LOCA at 11th and Belmont The Goat Blocks

Design Review Submittal (LU# 14-125908 DZM AD) (DAR# 13-224797) (Pre-Application# EA-203772)

PRESENTED BY: KILLIAN PACIFIC
OWNER: BELMONT INVESTMENT, LLC
ARCHITECT: ANKROM MOISAN ARCHITECTS
08.12.2014

East Building: Design Goals after DR 2

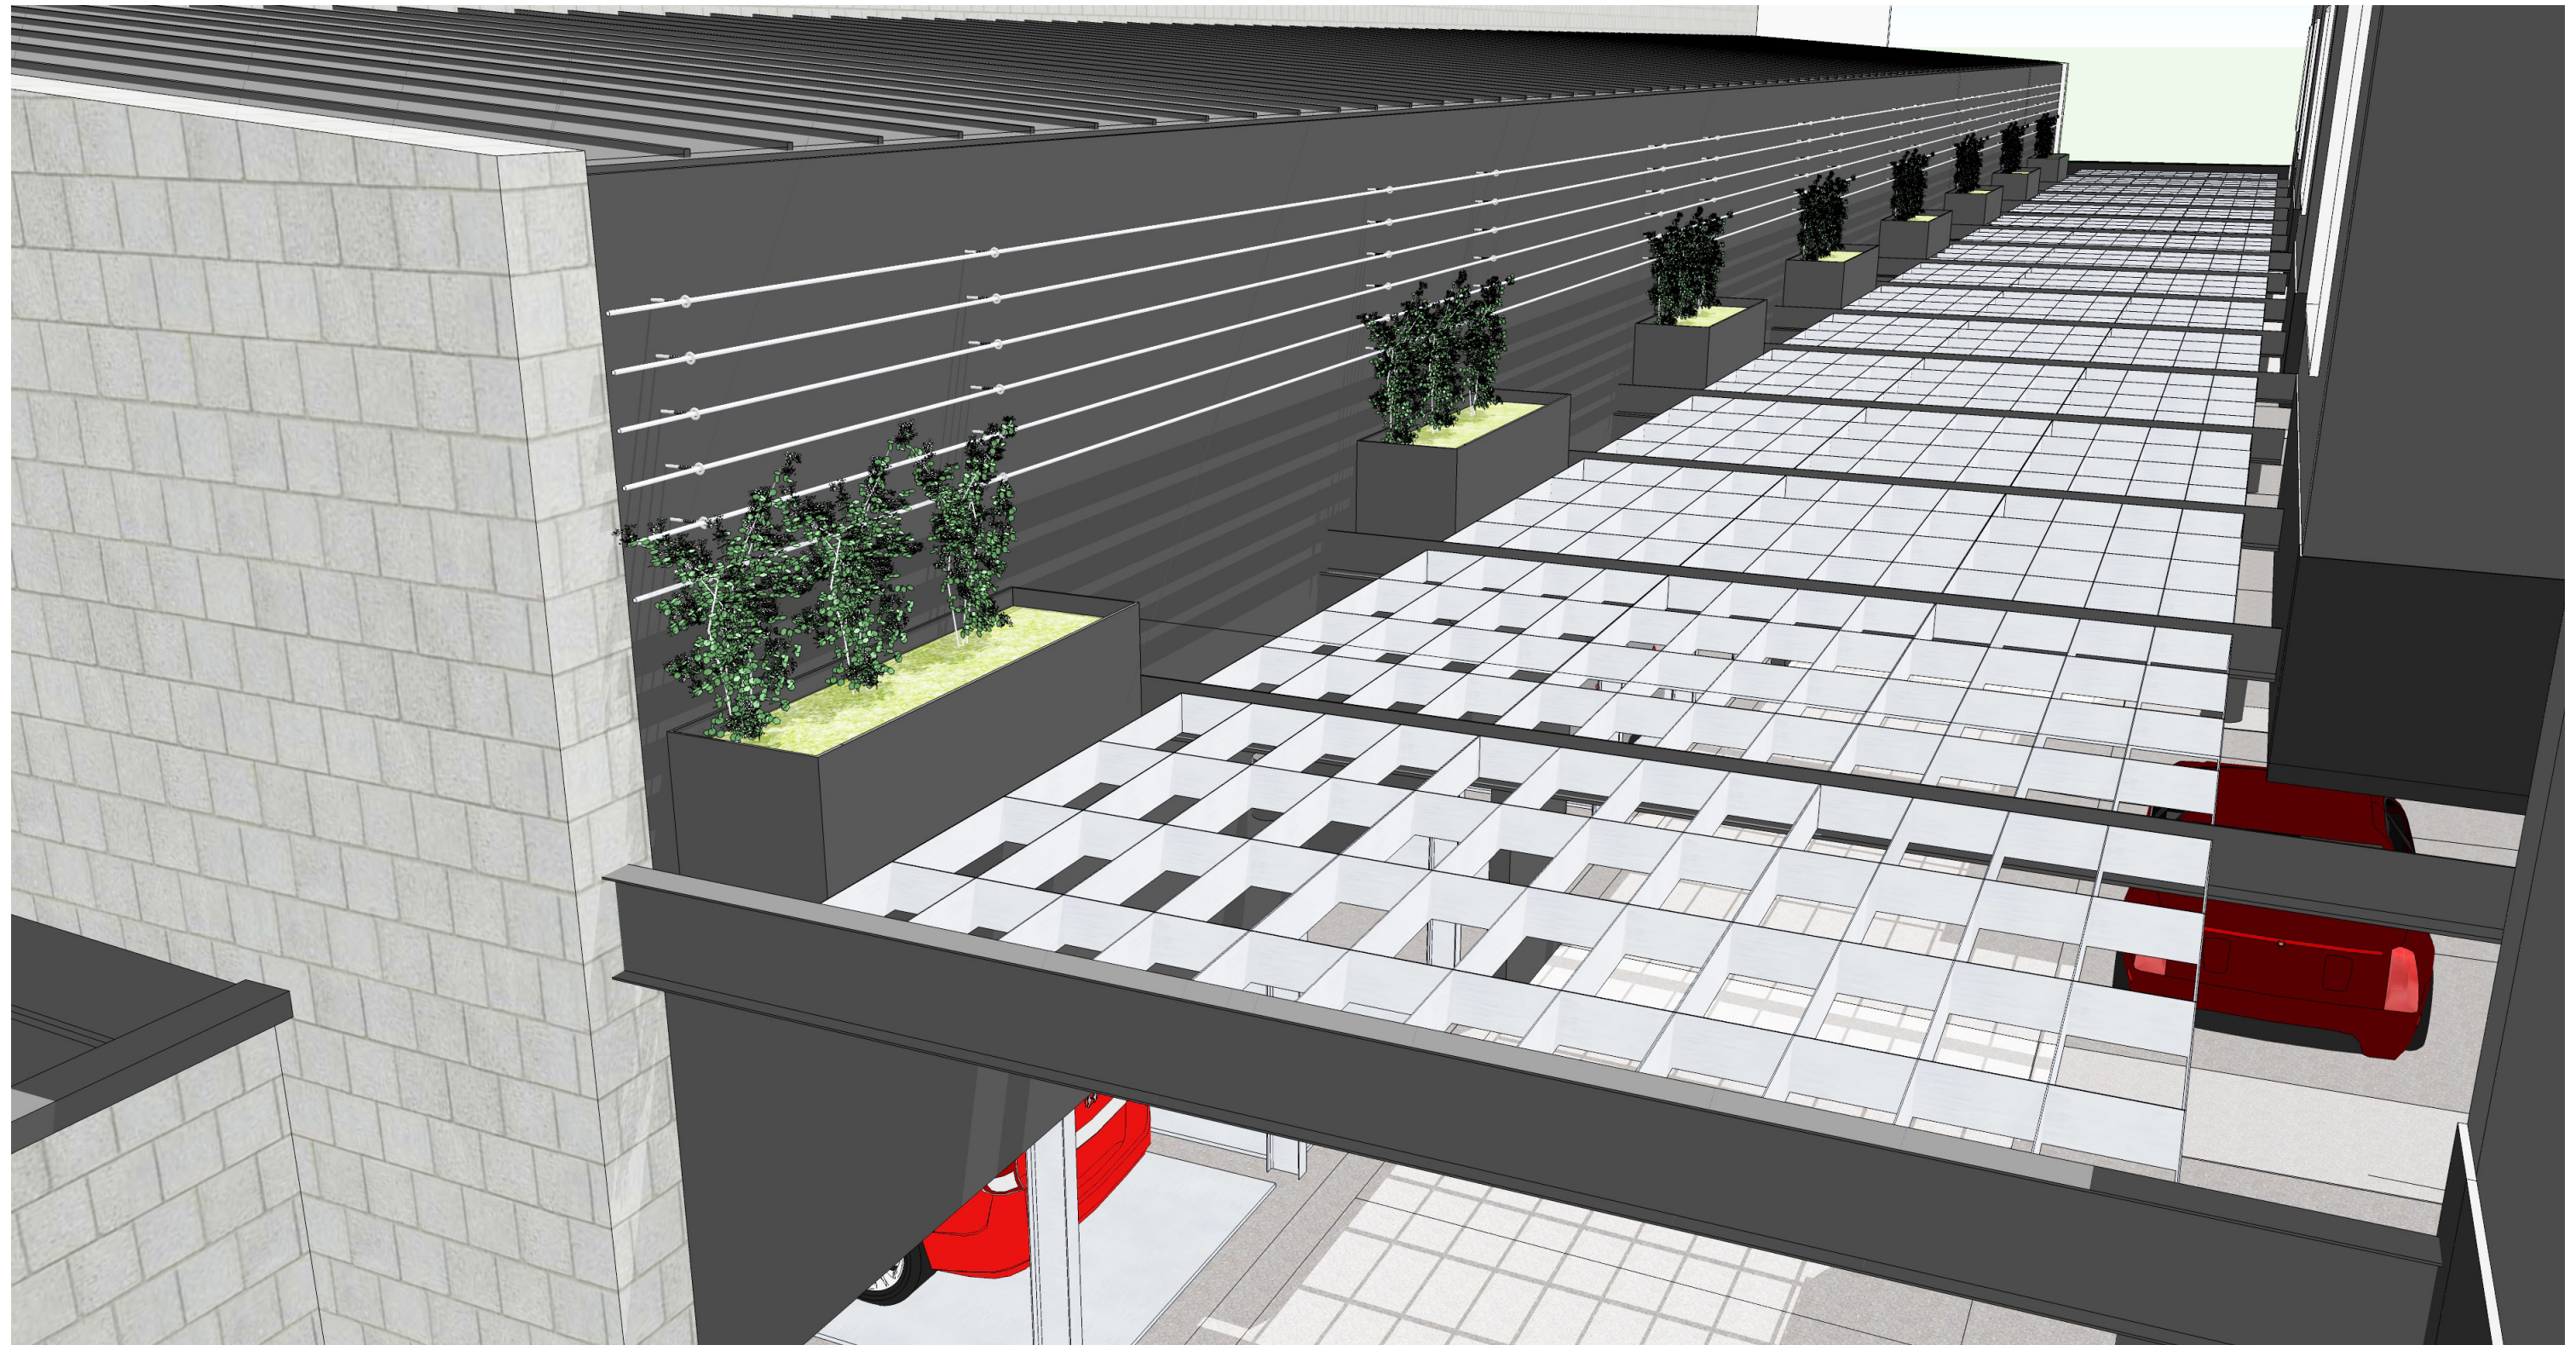
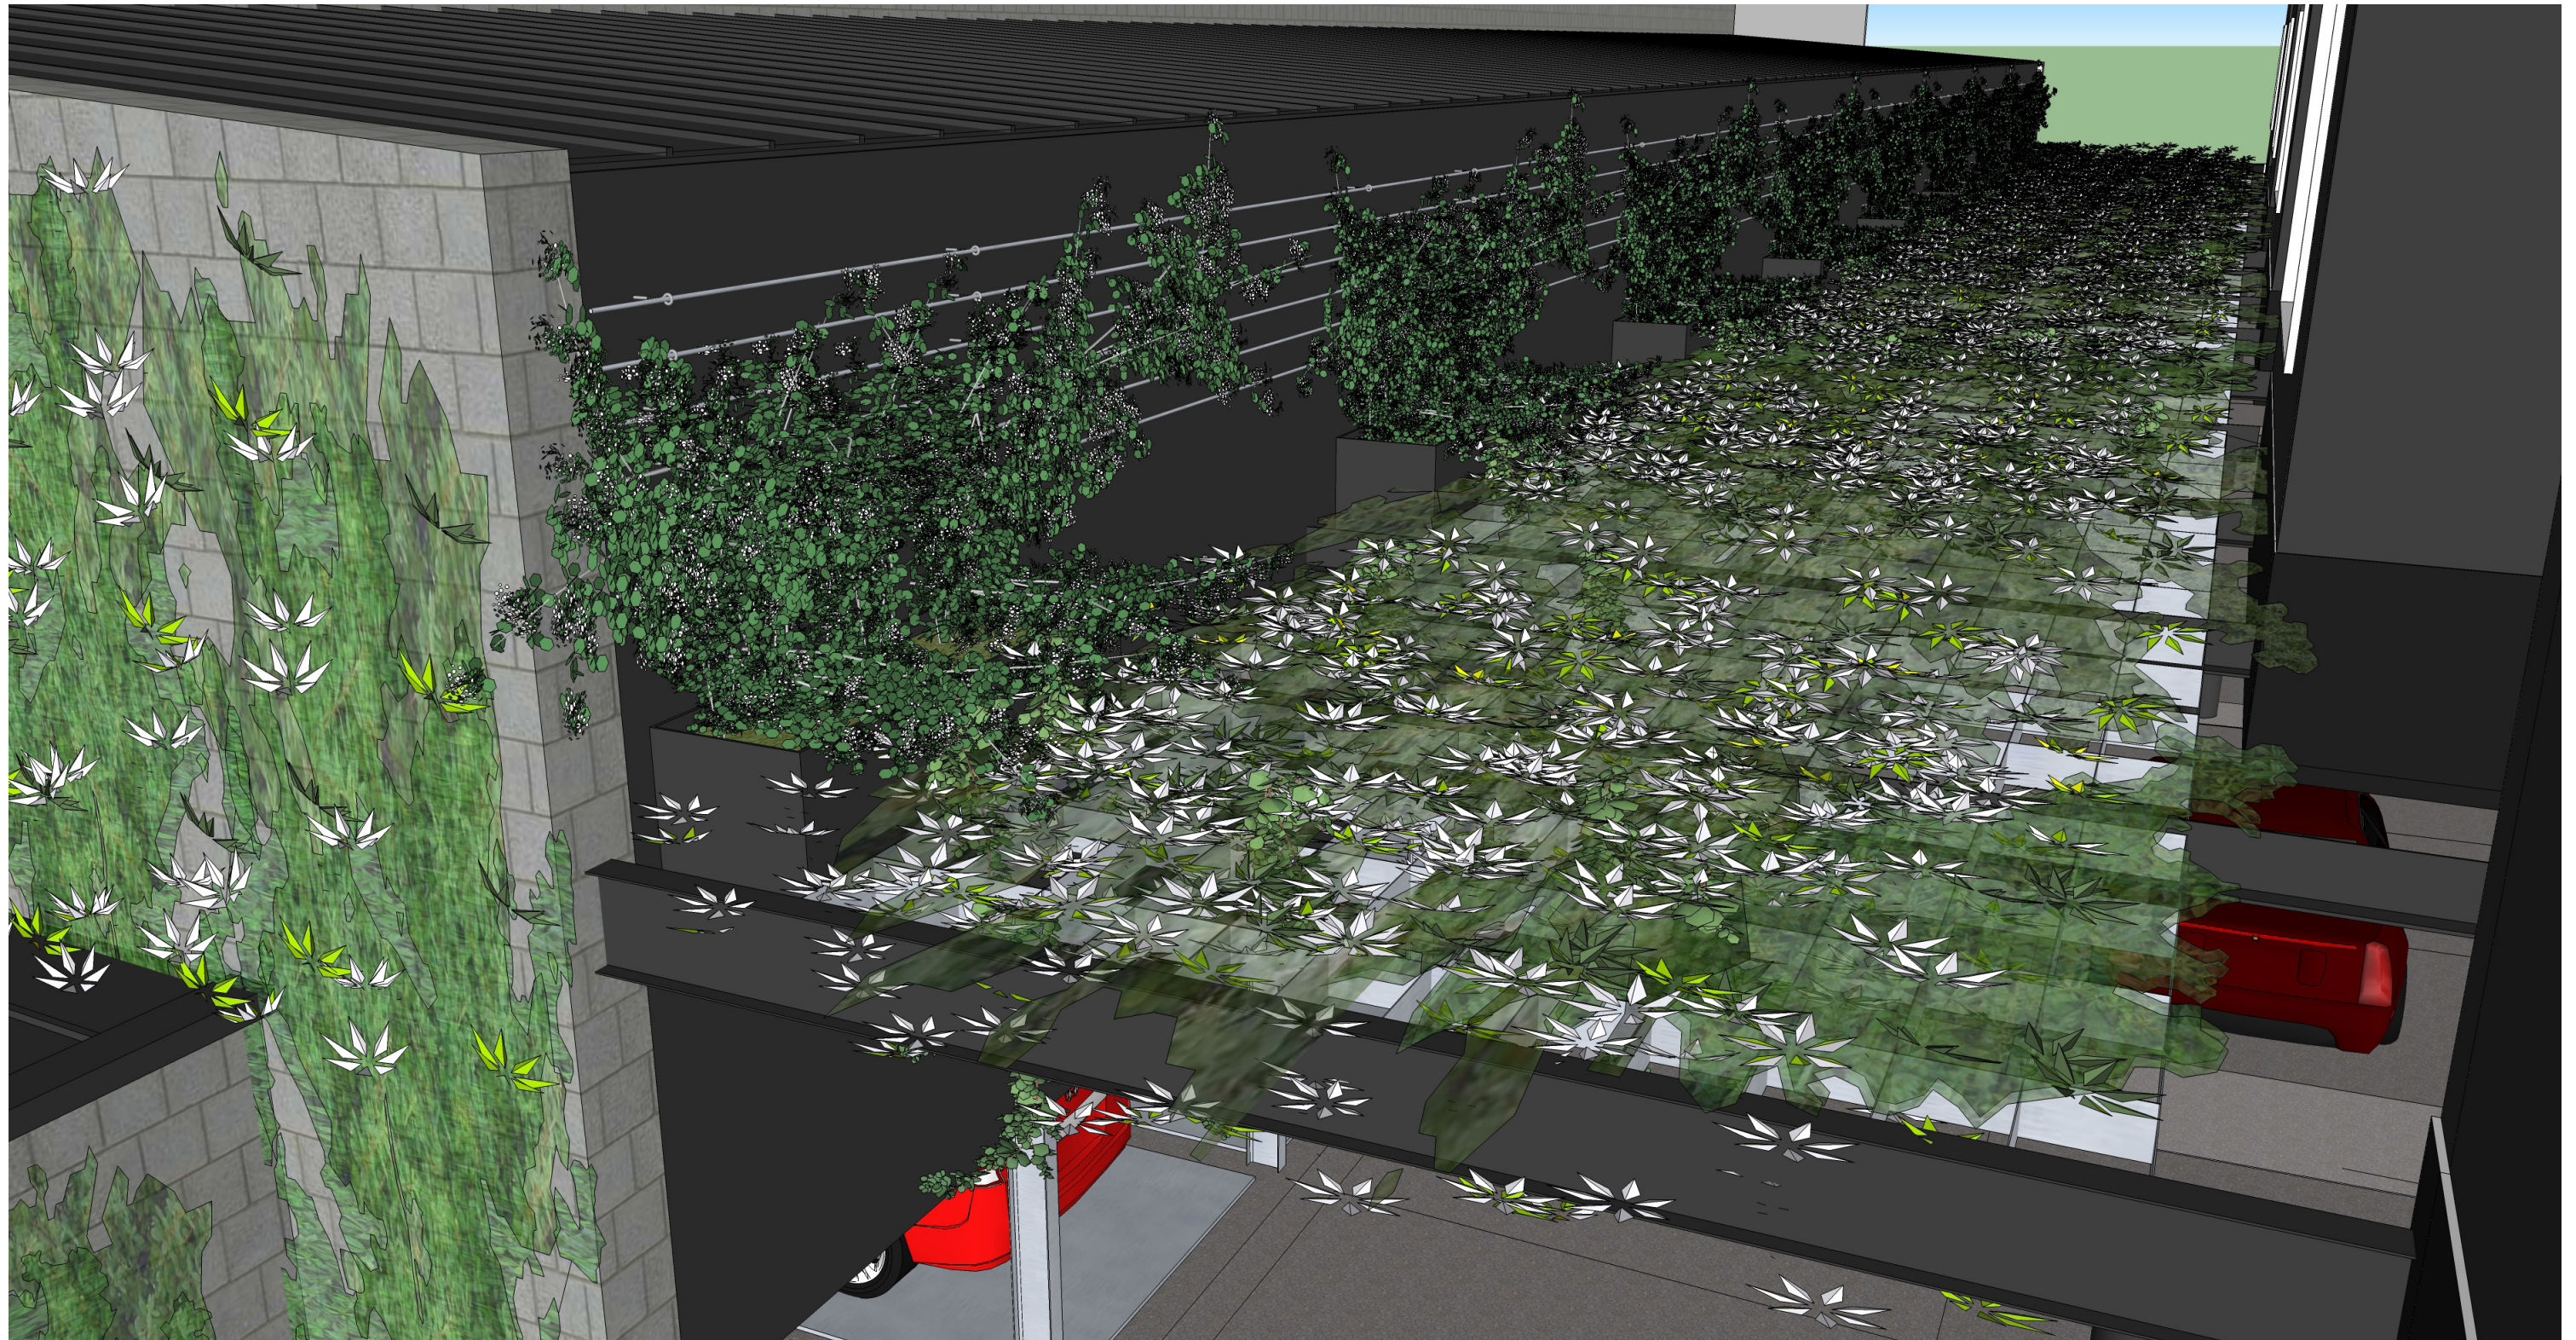
- Simplify and enhance design of base further, by removing natural wood siding
- Screen views from east facing units, towards mechanical parking
- Enhance clarity of walking vs. auto uses in parking area, to better protect pedestrian traffic
- Enhance Mechanical Parking Enclosure design
- Enhance overall design friendliness while maintaining clarity of design purpose.

East Building: Design Goals after DR 2

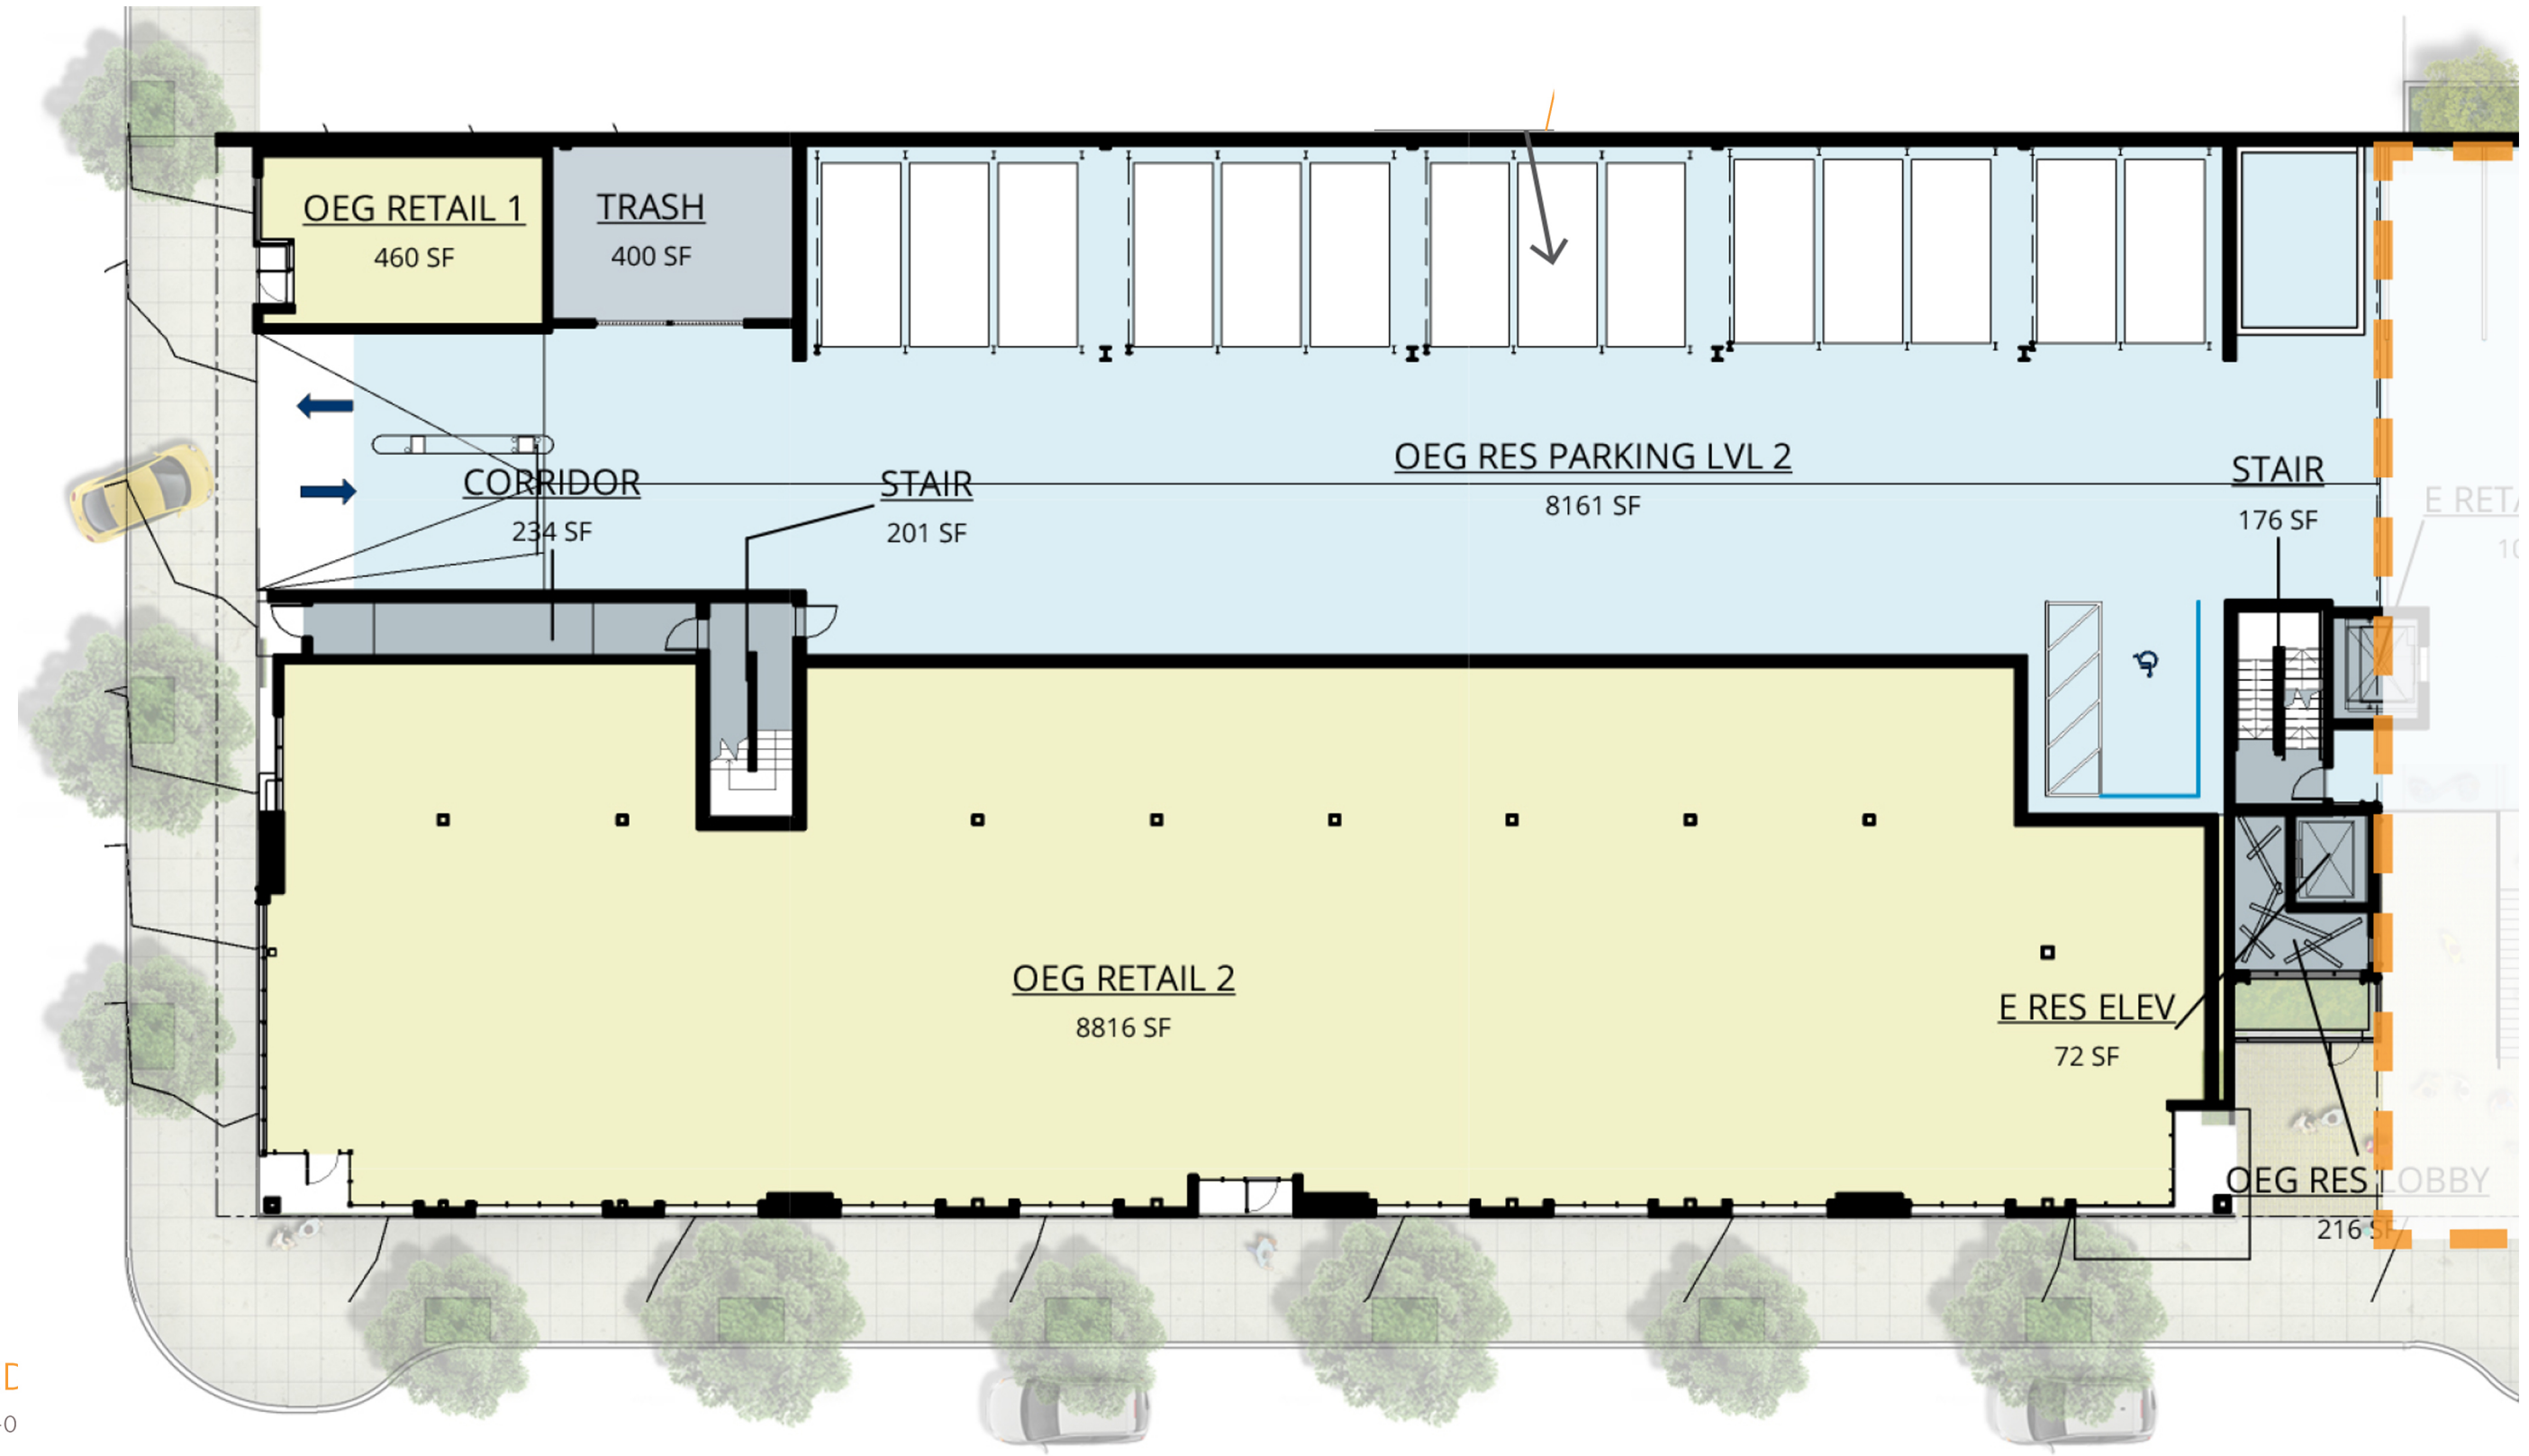
- Simplify and enhance design of base further, by removing natural wood siding
- Screen views from east facing units, towards mechanical parking
- Enhance clarity of walking vs. auto uses in parking area, to better protect the pedestrian
- Enhance Mechanical Parking Enclosure design
- Enhance overall design friendliness while maintaining clarity of design purpose, to provide parking. Not a pedestrian focused area.
